CLIO 2
MEGANE
SCENIC
LAGUNA
ESPACE

Cancels and replaces Technical Note No. 4024A dated April 2001.
Modifications: Change in After-Sales solution

11A NOISE FROM THE TIMING BELT

Technical Note: 3200A

Fig. 1

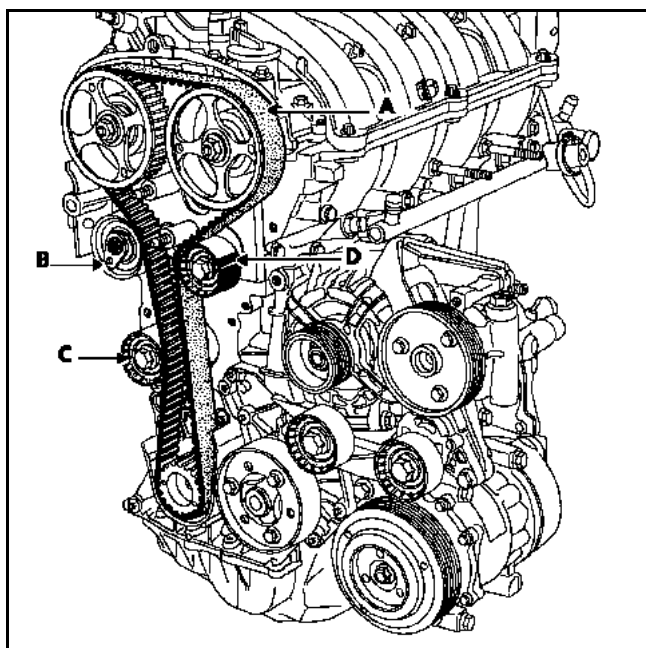
- Replace:
 - the toothed belt (A) (Fig.1),
 - the tension wheel (B) (Fig.1),
 - the grooved pulley (C) (Fig.1),
 - and its bolt and spacer
 - the smooth pulley (D) (Fig.1),
 - the accessories belt.
